**BELGISCH INSTITUUT VOOR POSTDIENSTEN  
EN TELECOMMUNICATIE**

**BESLUIT VAN DE RAAD VAN HET BIPT  
VAN 12 DECEMBER 2007  
MET BETREKKING TOT  
BROBA REACH EXTENDED ADSL2**

## Addendum n°4 to the Belgacom Reference Offer for Bitstream Access

### Reach Extended ADSL2

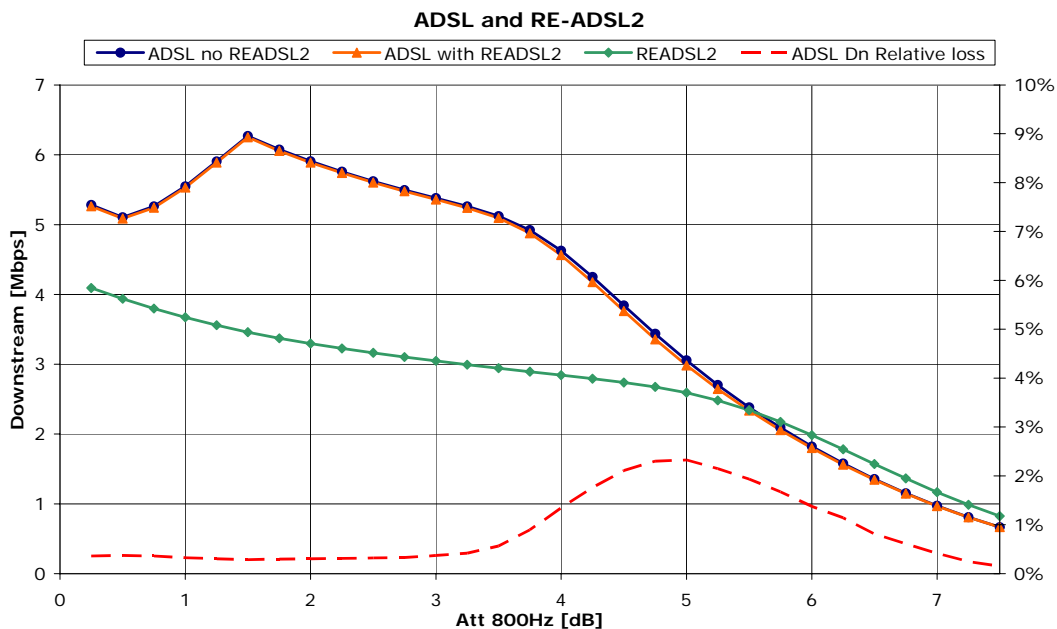
Betreffende geval Ila heeft Belgacom beslist de beste dienstverlening aan de klant aan te bieden. ADSL2 Reach Extended biedt betere prestaties boven 5,5 dB. Er is slechts een verschil van 0,25 dB tussen de minimum- en maximumattenuatie, dus ADSL2 Reach Extended zal pas vanaf 6,25 dB opduiken, waar de kwaliteit van Reach Extended duidelijk beter is dan ADSL.

Belgacom bemerkt ten slotte dat het belang van geval Ila in het juiste perspectief moet worden gezien. In de veronderstelling dat het gemiddelde verschil tussen de minimum- en maximumattenuatie 0,25 dB bedraagt, zal dit slechts een invloed hebben op een marginale 0,2% van de bevolking. Belgacom ziet de significantie van dit percentage niet in voor de OLO's.

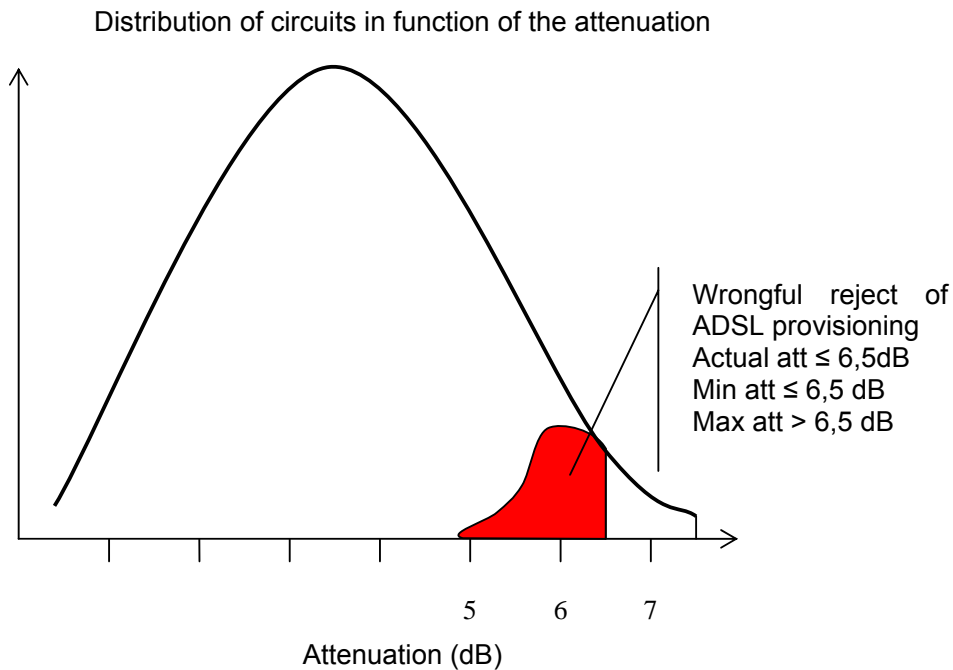
Mobistar, Tele2-Versatel & Scarlet gaan niet akkoord met de redenering van Belgacom. De impact kan niet berekend worden op basis van de bevolkingsdekking tussen 6,5 dB en 7,5 dB aangezien het verlies van ADSL-dekking enkel optreedt voor lijnen waar de werkelijke attenuatie onder 6,5 dB blijft. Daarnaast is enkel de gemiddelde spreiding van de circuits in geval Ila relevant en niet enkel de spreiding van hun laatste segment; daarom is de spreiding tussen min en max waarschijnlijk een veelvoud van 0,25 dB.

Aangezien de distributie van de circuits in functie van de attenuatie meestal niet plat is en de spreiding waarschijnlijk een veelvoud is van 0,25 dB, zullen de veronderstellingen van Belgacom waarschijnlijk een serieuze onderschatting zijn van de afname van de ADSL-dekking zoals zijn volgende figuur aantoont (voor redenering zie appendix 1).

De reductie van de dekking van ADSL ten voordele van ReADSL is verwaarloosbaar en bedraagt slechts 0,64%. Belgacom verplichten om vanaf de eerst mogelijke softwarerelease enkel BROBA ADSL te weigeren wanneer de minimumattenuatie boven 6,5 dB gaat, zou disproportioneel zijn.

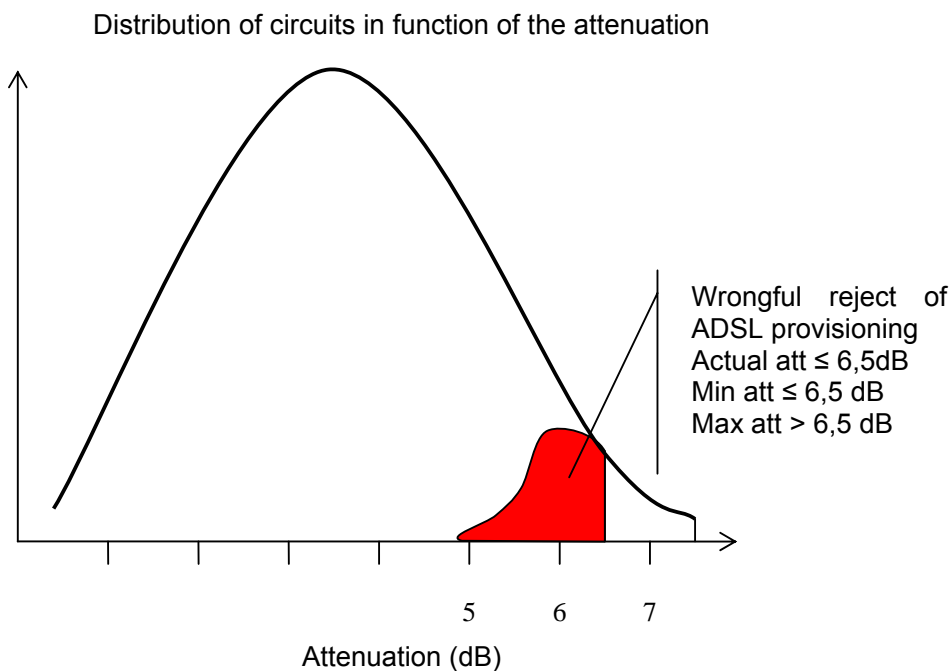
In order to assess this reduction of the population reached by ADSL only more precisely, one must quantify the cases where ADSL is wrongfully rejected i.e. where the actual attenuation  $\leq 6,5$  dB in case IIa.

Hereby one assumes within a segment an equal distribution, i.e. the actual attenuation for a given min – max attenuation pair is equally distributed between both values. This is a conservative assumption as the farther one gets from the city centre and thus the LEX, the less dense the population gets.

$$\text{Reduction} = P_{IIa} * (Avg_{casella}(att_{min}) - 6,5dB) / (Avg_{casella}(att_{min}) - Avg_{casella}(att_{max}))$$

This reduction may well be substantially larger than the 0,2% indicated by Belgacom as the figure below indicates.

Fig. 1

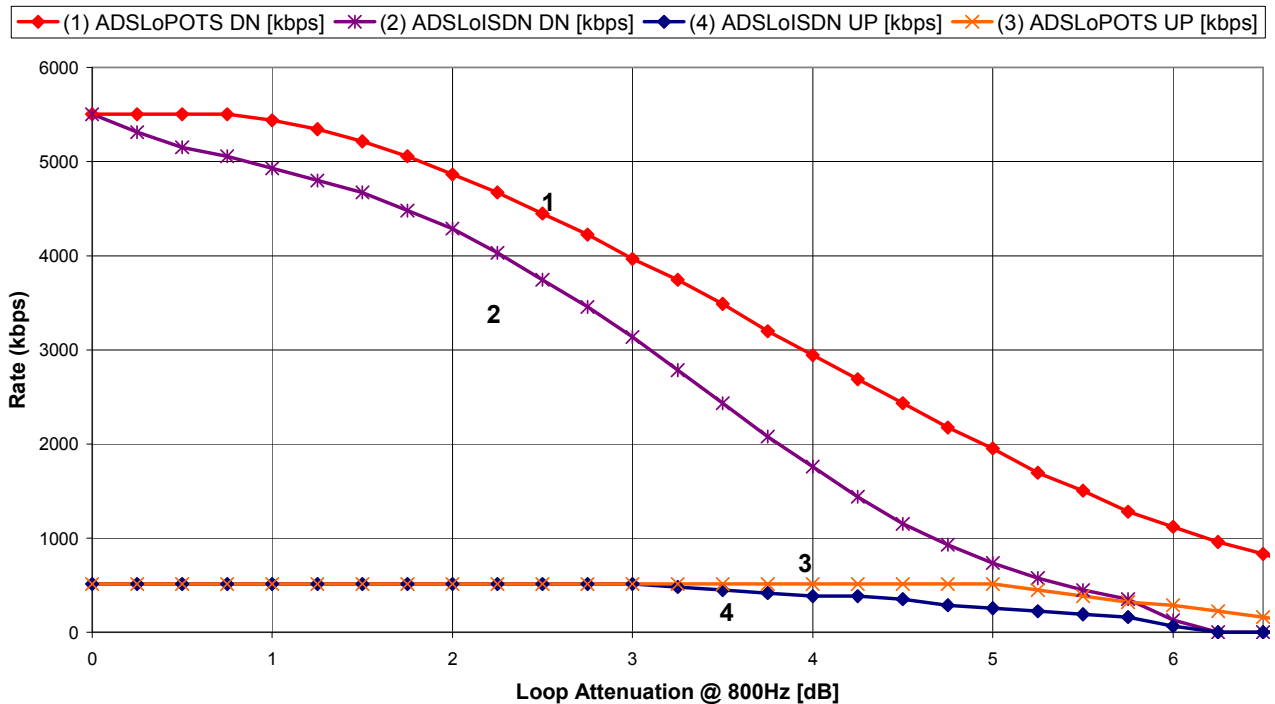
The section "ADSL deployment rule" must be replaced by :

74. ADSL is allowed for loops with attenuation at 800Hz less than 6,5dB.

75. Reach Extended ADSL2 is allowed for loops with attenuation at 800Hz comprised between 6,5 and 7,5dB.

77. In order to improve the provisioning process and the repair process of Broba II, ADSL deployment curves have been developed on basis of statistics of actual network. Different curves are defined for ADSL over POTS and for ADSL over ISDN as well as for the upstream and the downstream for both ADSL flavours. Those curves are only deployment rules and not a performance guarantee. The curves are subject to evolution and could be reviewed.

The axes of the above graphic are the loop attenuation at 800Hz, versus the attainable bit rate.  
 Line 1, the most upper line, represents the ADSL over POTS downstream.  
 Line 2 represents the ADSL over ISDN downstream.  
 Line 3 represents the ADSL over POTS upstream.  
 Line 4 represents the ADSL over ISDN upstream.
